January 11, 2002

**RESPONSES TO FCC QUESTIONS ON THE SAR COMPLIANCE TEST
REPORT OF ATHEROS MODEL AR5BCB-00013
DATED NOVEMBER 20, 2001**

Fig. a. Plot of the SAR variations as a function of depth in the liquid for locations of peak SAR from Tables 1 and 2 (Above-lap position) of the SAR Compliance Test Report.

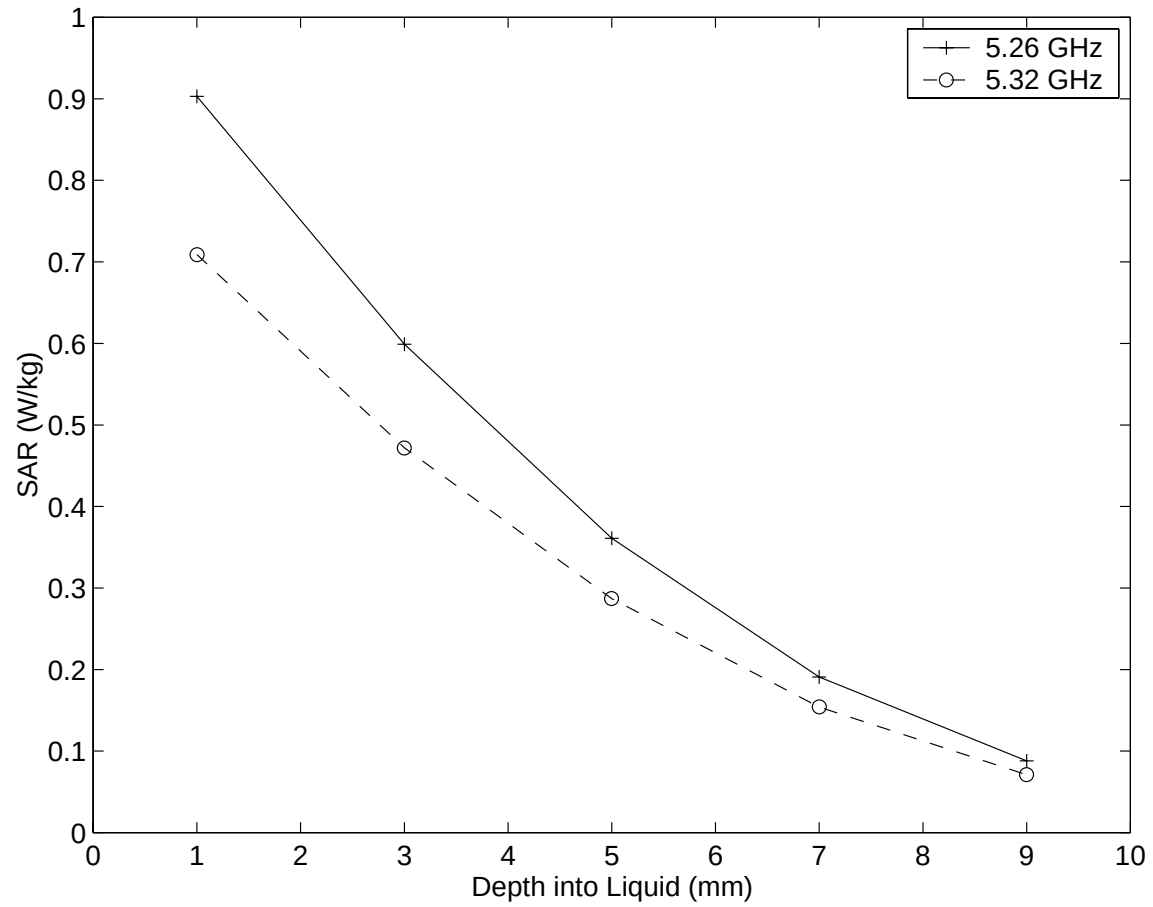
5. To verify liquid depth and proper test system operation, we have been requesting graphs of SAR vs. depth into liquid at the peak SAR configuration(s). In future filings, please provide such graphs.

The measured variations of SAR vs. depth into the liquid at the peak SAR locations from Tables 1 and 2 of the SAR report are plotted in Fig. a while those from Tables 3 and 4 of the SAR report are plotted in Fig. b. Both Figs. a and b are attached here.
